Airworthiness Concern Sheet

Make, Model, Series, Serial No.: Taylorcraft, all models equipped with landing gear.

Reason for Airworthiness Concern: Failure of the Main Landing Tie Strut, Part Number B-A51

SERVICE BULLETIN

FIG. 1.

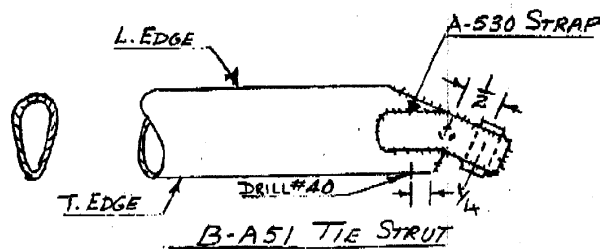
COMPLIANCE PROCEDURE: (1) Inspect landing gear tie strut (TAC P/N B-A51) near "bolt" at axle for obstruction or foreign material in drain hole

Note that drain hole is either located at center of strap (TAC P/N A-530) and/or at trailing edge of tie strut. Only one hole is sufficient for drainage.

(2) If drain hole(s) is (are) plugged, open with suitable means.

(3) If none of the drain holes exist, drill #40 in trailing edge as shown in Fig. 1.
